APPLICATION NO.	FILING DATE	FIRST NAMED INVENTOR	ATTORNEY DOCKET NO.	CONFIRMATION NO.
18/532,841	12/07/2023	Tao TAO	024607-02-5134-US	6615
24341	7590	04/15/2025		
Morgan, Lewis & Bockius LLP (PA) 1400 Page Mill Road Palo Alto, CA 94304-1124			EXAMINER DOMONE, CHRISTOPHER P	
			ART UNIT	PAPER NUMBER
			1725	
			NOTIFICATION DATE	DELIVERY MODE
			04/15/2025	ELECTRONIC

APPLICATION NO.	ISSUE DATE	PATENT NO.
18/532,841	15-Apr-2025	12278330

ISSUE NOTIFICATION

FIG. 5C

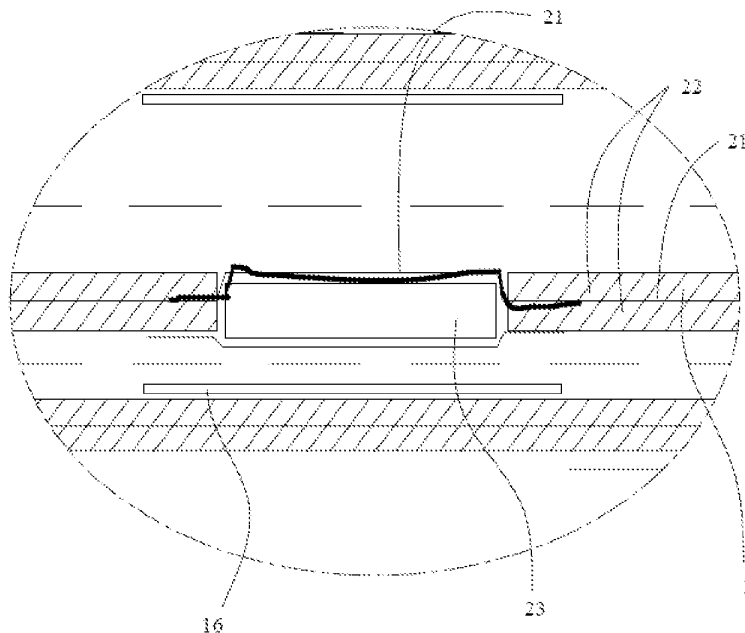
Moreover, as highlighted above in FIG. 1 of Sugita, there is an active substance layer on the other side of the negative current collector opposite to the negative tab 6, which prevents the negative current collector from “extend[ing] towards the center of the battery” as required by the pending claim 1 and supported by FIG. 5C of the present application with highlights (reproduced below).

In view of the above, the Applicant respectfully submits that claim 1 and its dependent claims 3 and 8 are not anticipated by Sugita. Because claim 11 recites the same claim feature required above, claims 11 and its dependent claims 13 and 18 are also not anticipated by Sugita.
